Presentation: Historically and architecturally significant attributes of PW and PG

CITY OF SANTA CLARA (Annotated) SINGLE-FAMILY AND DUPLEX RESIDENTIAL

1075 POMEROY AVENUE
ALTERNATIVES TO PROPOSED DEVELOPMENT
SITE PLAN

Figure 2.7 - Second-story windows on *House A* are raised at least five feet above the finished floor, reducing privacy impacts.

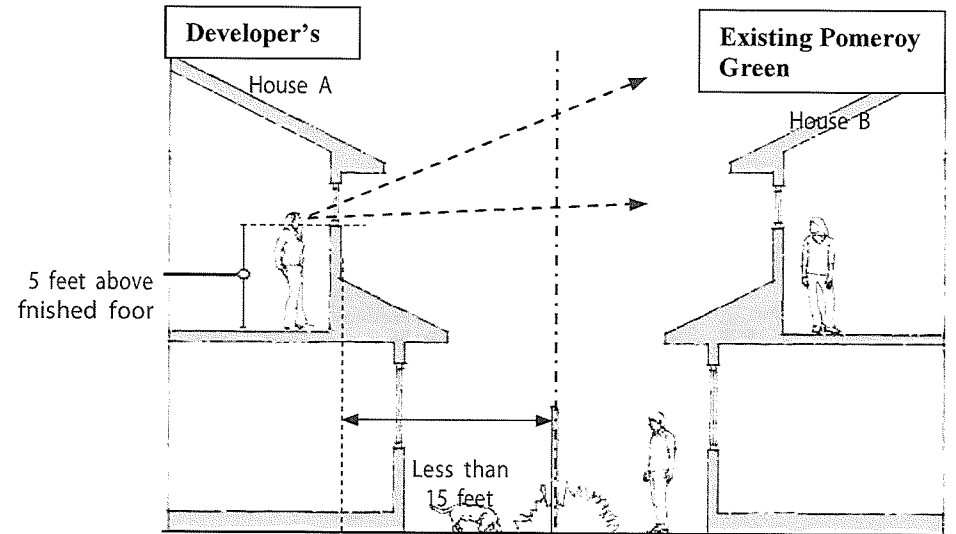
Project provides large 2nd floor windows A1 & B1 that are directly opposite 2nd floor windows in the adjacent Pomeroy Green building Q

Figure 2.10 - Trees and landscaping can block the line of sight into neighboring private spaces.

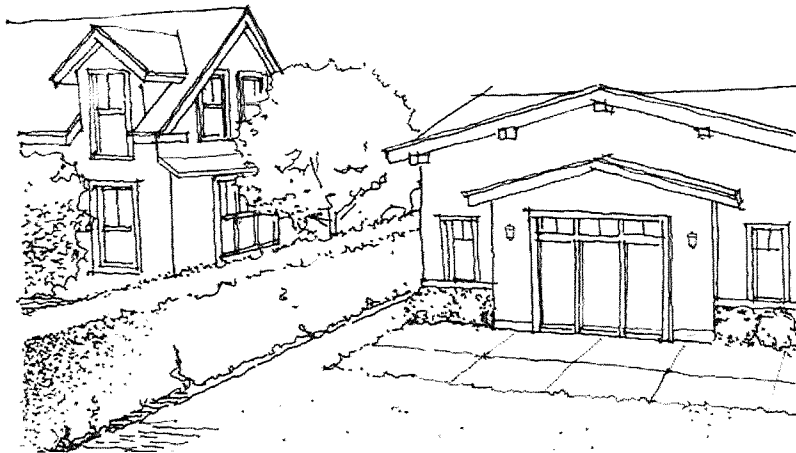
5. On second-floor bathroom windows, use obscure glass where possible and/or substitute a skylight.
6. Install landscaping that may grow to block the line of sight into neighboring side and rear yard whenever feasible. This includes planting trees, and adding landscaping on trellises or arbors that meet Zoning requirements.
(Figure 2.10) 50% line-of-sight due to lack of tree & small tree selection

Figure 2.13 - Typical patio home features.

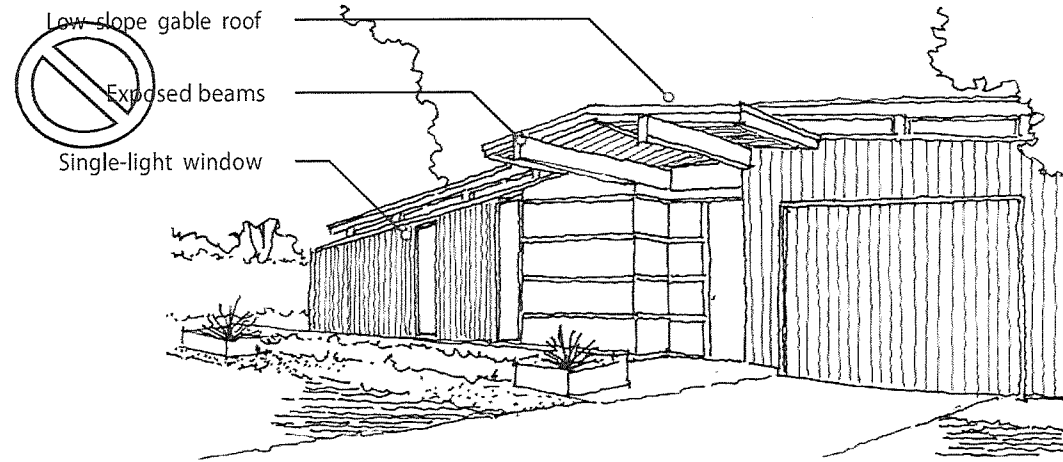
Project fails to meet design guidelines

Figure 3.1 - Homes with compatible scale massing.

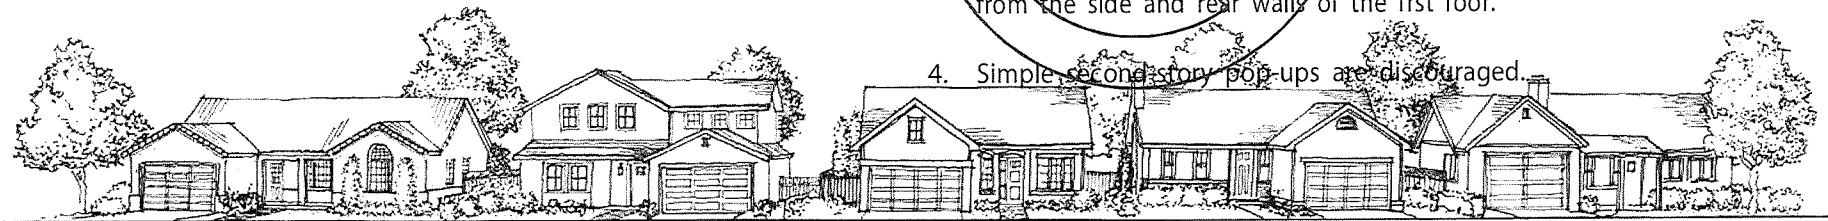
The proposal's "contemporary" design is NOT compatible with the Eichler mid-century modern design homes in Pomeroy Green and Pomeroy West

Figure 4.1 - Block of homes demonstrating setback patterns.

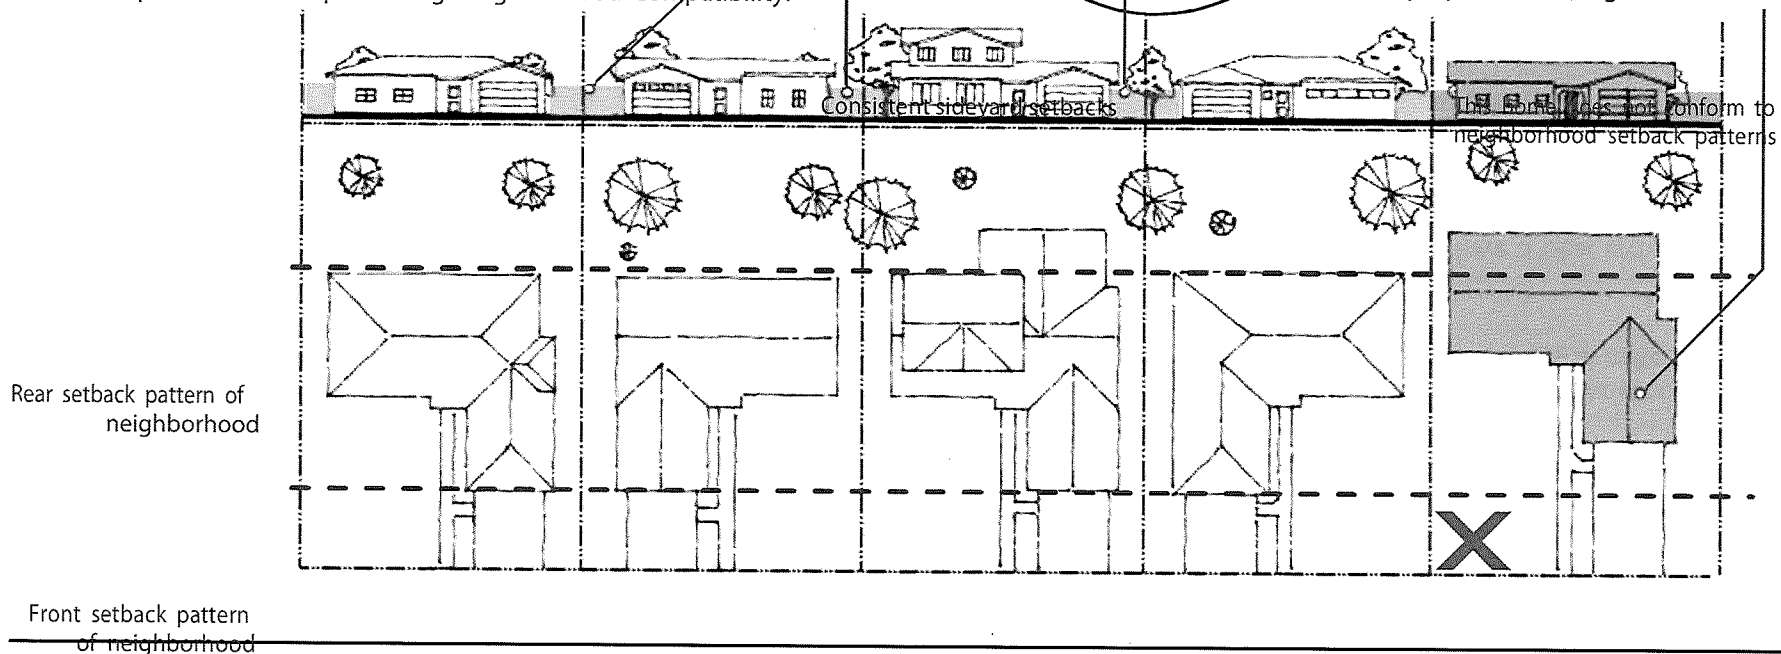
Major Failure

1. The location and orientation of a new home on a lot should be consistent with the prevailing patterns found in the neighborhood. (Figure 4.1)
2. Front and street side yard setbacks should match or not extend beyond that which is typical for the block and appropriate for the scale of the proposed building.

Figure 4.2a - Second-story addition with larger side setbacks to reduce shading of neighboring properties.

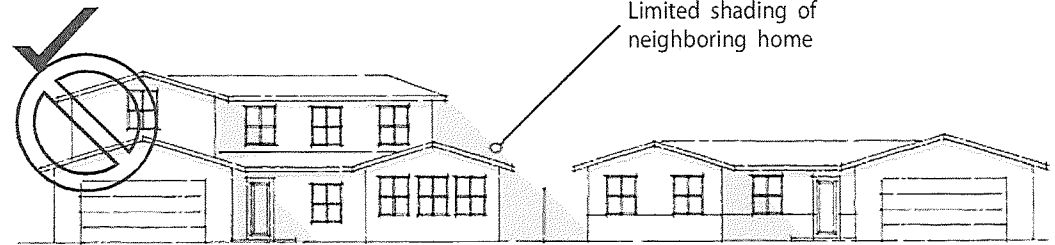
3. Proposed designs should minimize, to the extent possible, shading of adjacent homes and private yards. Impacts of scale, shadow, views, air, and light and other consequences of development upon nearby properties may require use of greater setbacks to provide less shading. (Figure 4.2) **Major Failure**

9. Building pad heights should be determined early in the interests of food hazard mitigation, stormwater runoff, design treatment of building elevations, and to consider appropriate measures to protect privacy on surrounding properties. **Lower Pad 1' 0"**

Developer's design – street side view of one proposed home

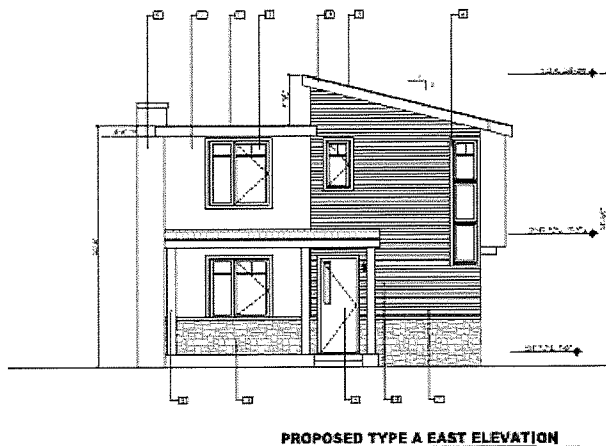
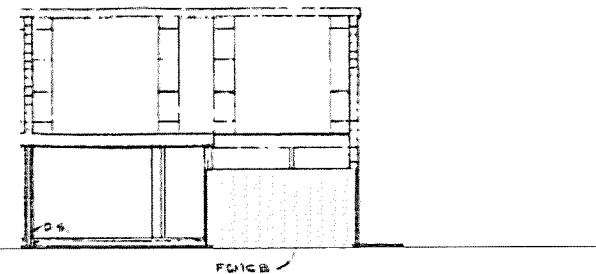
Developer proposed designs violate all the preceding listed City of Santa Clara guidelines! (compatibility with neighboring homes, privacy, material choice, building height, etc.)

Note: These are to scale renditions and demonstrate the size incompatibility that will be apparent if located next to each other.
